**Daniels Field Multipurpose Recreational Area Project
For the Boys and Girls Clubs of the Los Angeles Harbor
1200 S. Cabrillo Avenue, San Pedro, CA 90731**

**Addendum One (1)
Issued April 25, 2013**

**Daniels Field Multipurpose Recreational Area Project
For the Boys and Girls Clubs of the Los Angeles Harbor
1200 S. Cabrillo Avenue, San Pedro, CA 90731
Addendum Two (2) - Bid Due Date Extension and New Fence Specifications
Issued May 3, 2013**

**Daniels Field Multipurpose Recreational Area Project
For the Boys and Girls Clubs of the Los Angeles Harbor
1200 S. Cabrillo Avenue, San Pedro, CA 90731
Addendum Three (3) - New Chain Link Fence Specifications
Issued May 7, 2013**

FENCE HEIGHT GUIDE - RFI # 2

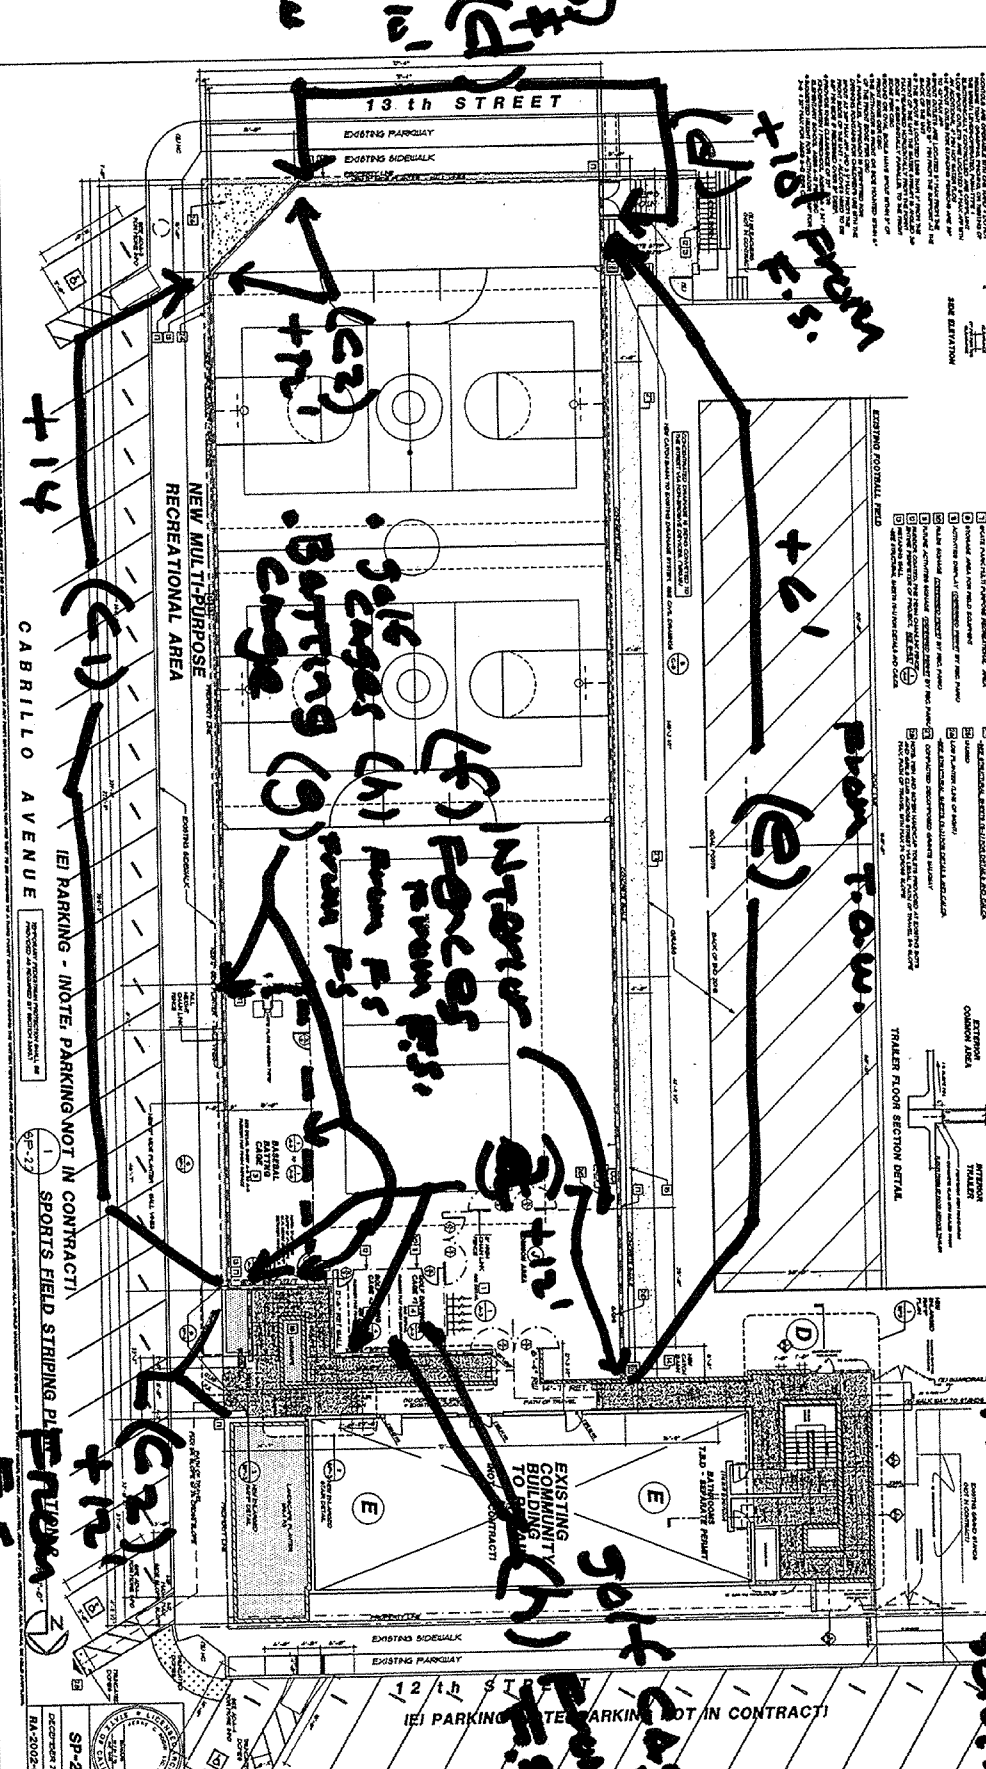
14. Chain link Fence pipe(s) and railing(s) to be powder coat painted.
- b. Fence heights (see Fence Height Guide on page 4 of this RFI)
 - i. North Fence 12’-0” (a)

- ii. South Fence -partial south fence 10’-0” (and see east fence below for diagonal fence height 12’-0”)
 - iii. East Fence - (c1) Upper fence at sports area 14’-0”. (c2) Lower Fence at south east diagonal corner 12’-0”

- iv. West fence at exit stair – approx 10’-0” (d) (and partial south fence)
 - v. West Fence 6’-0” (e)
 - vi. Interior fences 8’-0” (f)
 - vii. Batting Cage (interior sides) 12’-0” (g)

- viii. Golf cages (interior sides) 12’-0” (h)

REF # 17
 GATES

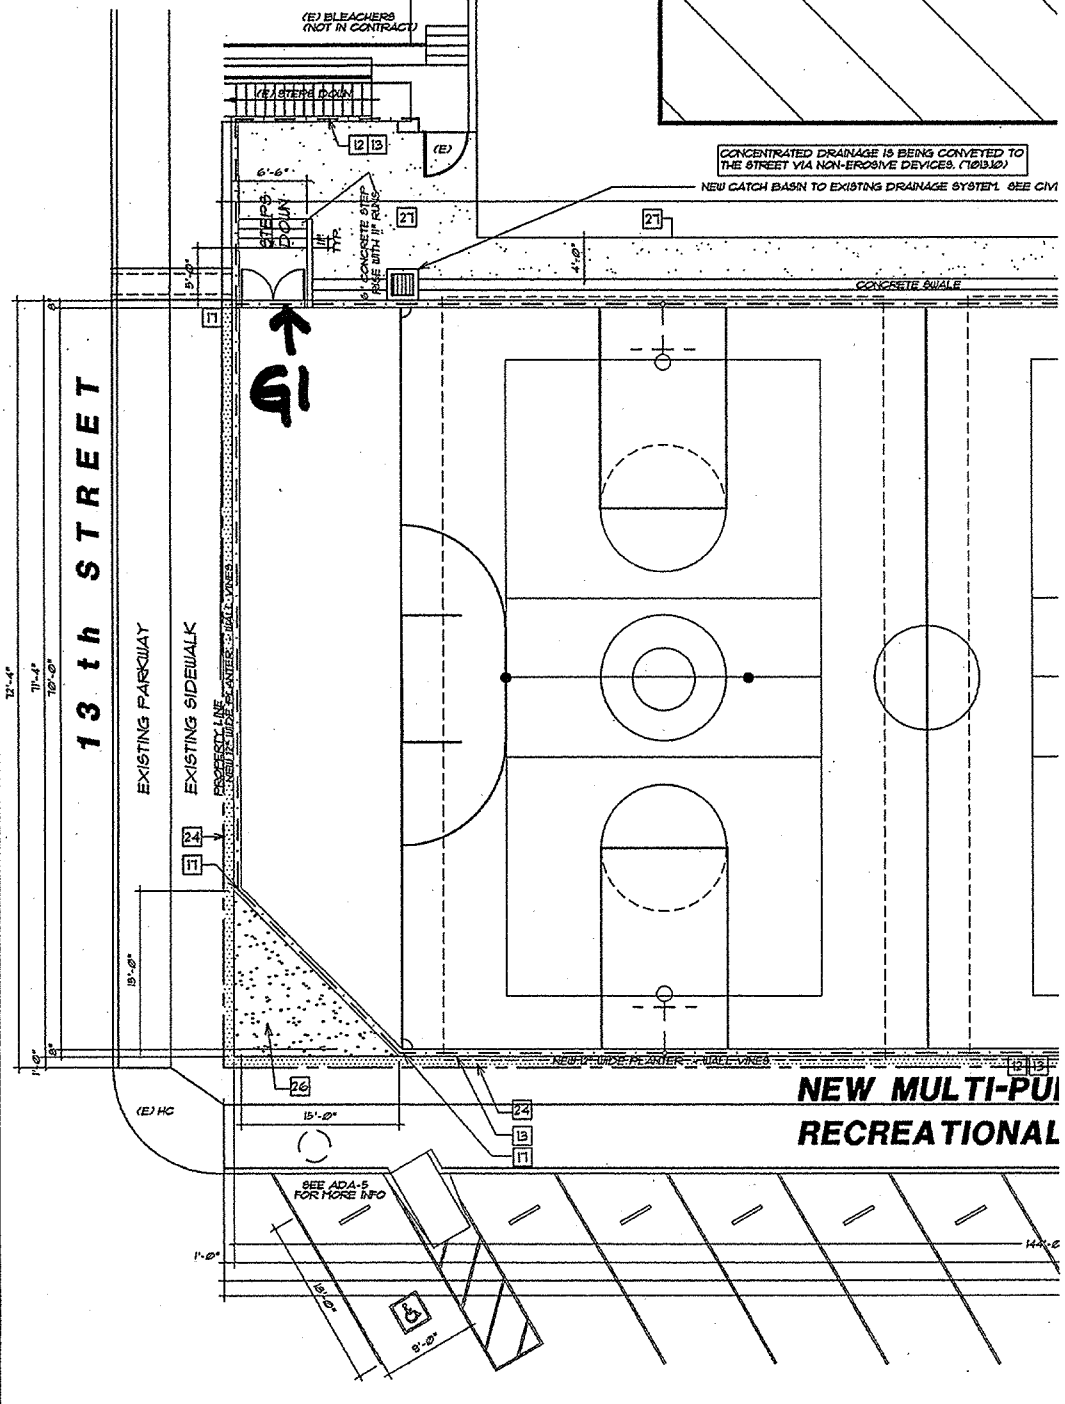
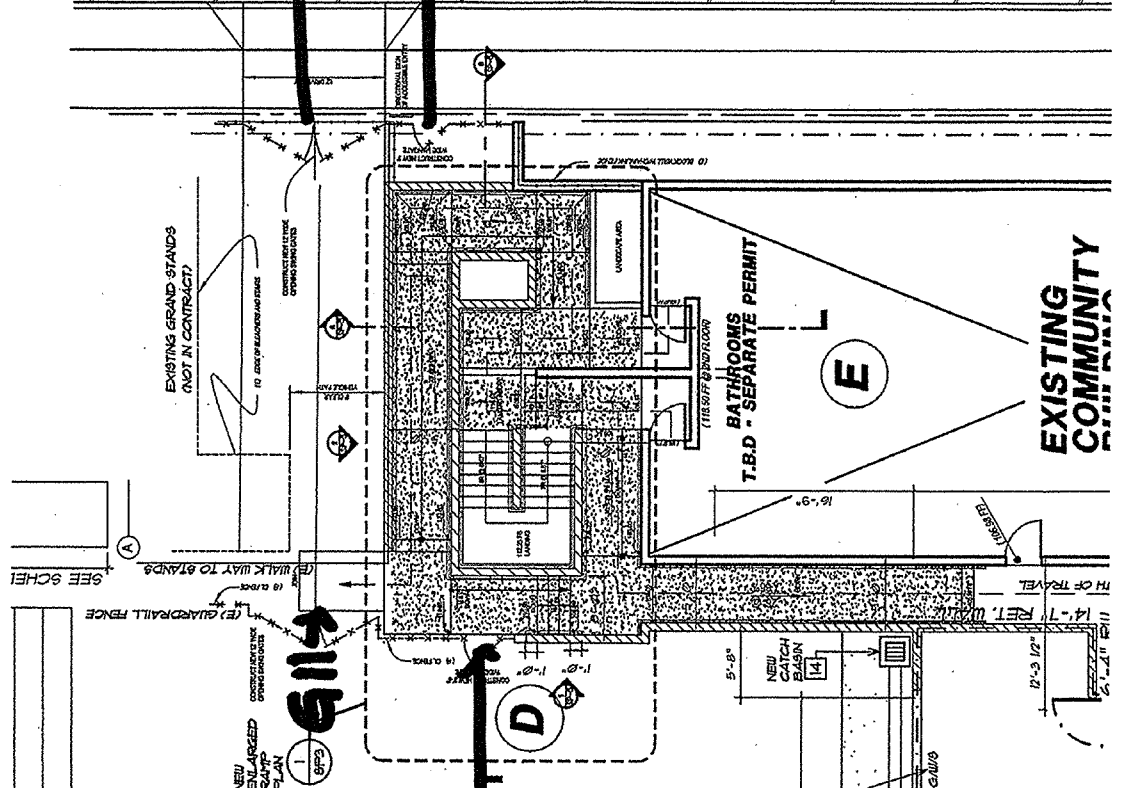
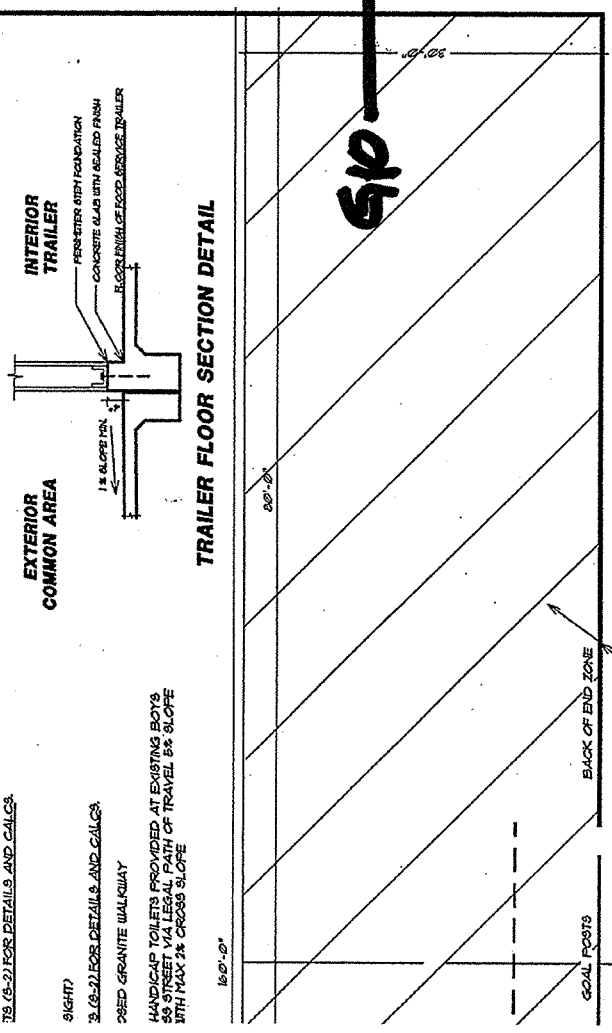
On the next 4 pages is a revised Gates key plan (4 sheets) for the project. Noted below is the new Gates Schedule. This new schedule replaces the existing door schedule located on SP-2.1 and SP-2.2. These revised gates are in response to the revised fence heights required due to the Basketball court back board heights. The fence heights were covered in the recent RFI#10.

<u>SYM</u>	<u>TYP</u>	<u>W. x H</u>
G-1	(pair)	3'-0" x 10'-0"
G-2	(single)	3'-0" x 8'-0"
G-3	(single)	3'-0" x 8'-0"
G-4	(single)	3'-0" x 8'-0"
G-5	(single)	3'-0" x 8'-0"
G-6	(pair)	3'-0" x 8'-0"
G-7	(pair)	4'-0" x 8'-0"
G-8	(pair)	4'-0" x 12'-0"
G-9	(pair)	3'-0" x 12'-0"
G-10	(single)	3'-6" x 3'-6"
G-11	(pair)	6'-0" x 3'-6"
G-12	(pair)	6'-0" X 12'-0" (field verify)
G-13	(single)	3'-0" x 12'-0" (field verify)
